FINAL DRAINAGE REPORT

WALDEN PRESERVE 2 – FILING NO. 4

September 5, 2018
Revised February 26, 2019

**JPS Project No. 040201
PCD File No. SF-18-034**

Detention Basin Outlet Structure Design

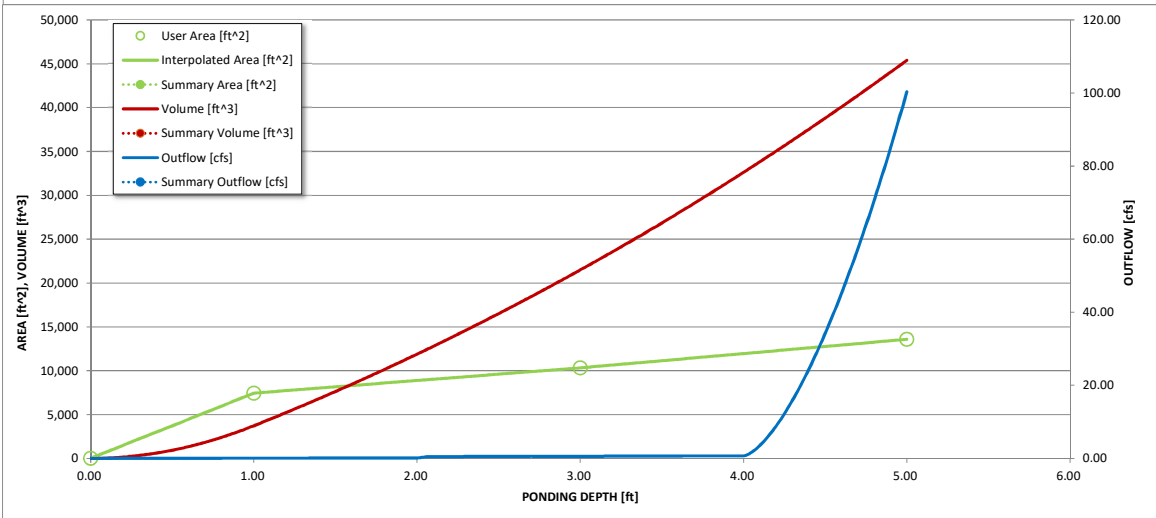
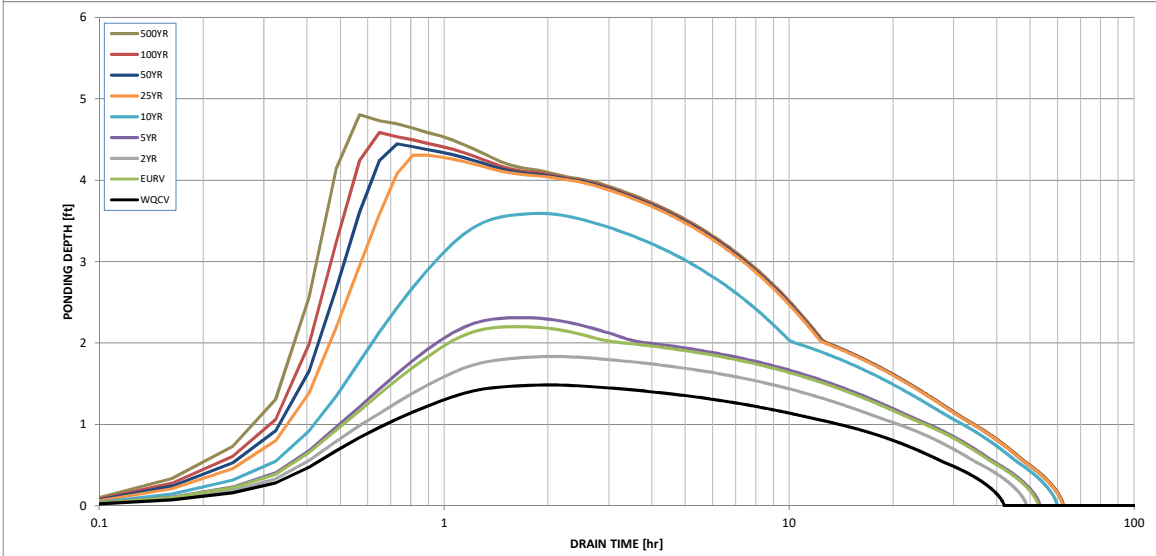
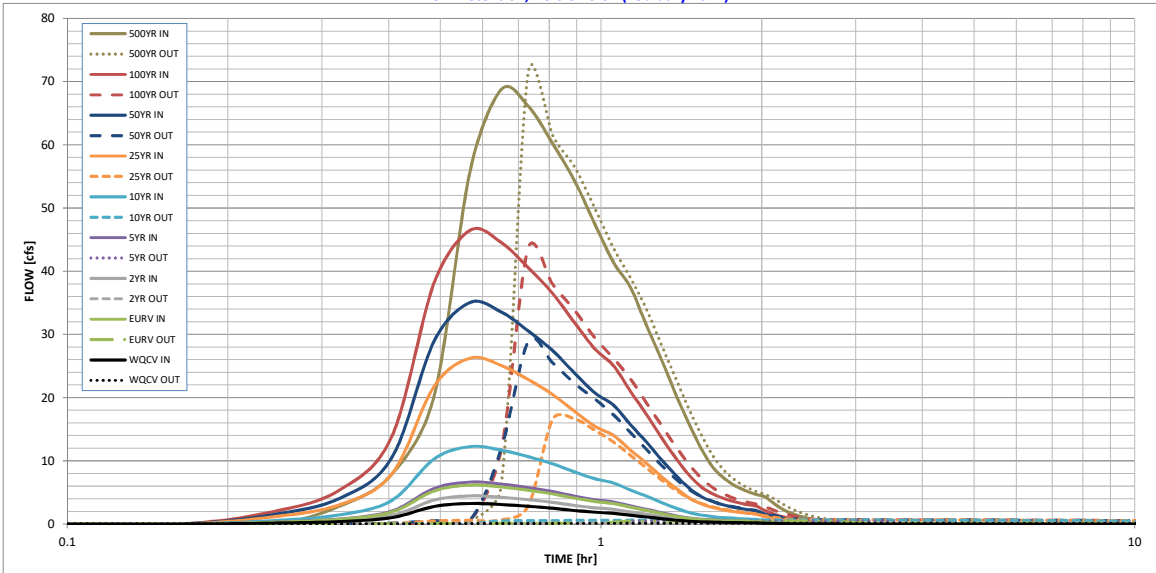
<p>6. Trickle Channel</p> <p>A) Type of Trickle Channel</p> <p>F) Slope of Trickle Channel</p>	<p style="color: blue;">PROVIDE A CONSISTENT LONGITUDINAL SLOPE FROM FOREBAY TO MICROPOOL WITH NO MEANDERING. RIPRAP AND SOIL RIPRAP LINED CHANNELS ARE NOT RECOMMENDED. MINIMUM DEPTH OF 1.5 FEET</p> <p style="padding-left: 40px;">Choose One <input type="radio"/> Concrete <input checked="" type="radio"/> Soft Bottom</p> <p>$S =$ <u>0.0050</u> ft / ft</p>
<p>7. Micropool and Outlet Structure</p> <p>A) Depth of Micropool (2.5-foot minimum)</p> <p>B) Surface Area of Micropool (10 ft² minimum)</p> <p>C) Outlet Type</p> <p style="padding-left: 40px;">Choose One <input checked="" type="radio"/> Orifice Plate <input type="radio"/> Other (Describe): _____ _____ _____</p> <p>D) Smallest Dimension of Orifice Opening Based on Hydrograph Routing (Use UD-Detention)</p> <p>E) Total Outlet Area</p>	<p>$D_M =$ <u>2.5</u> ft</p> <p>$A_M =$ <u>10</u> sq ft</p> <p>$D_{orifice} =$ <u>1.19</u> inches</p> <p>$A_{ot} =$ <u>3.48</u> square inches</p>
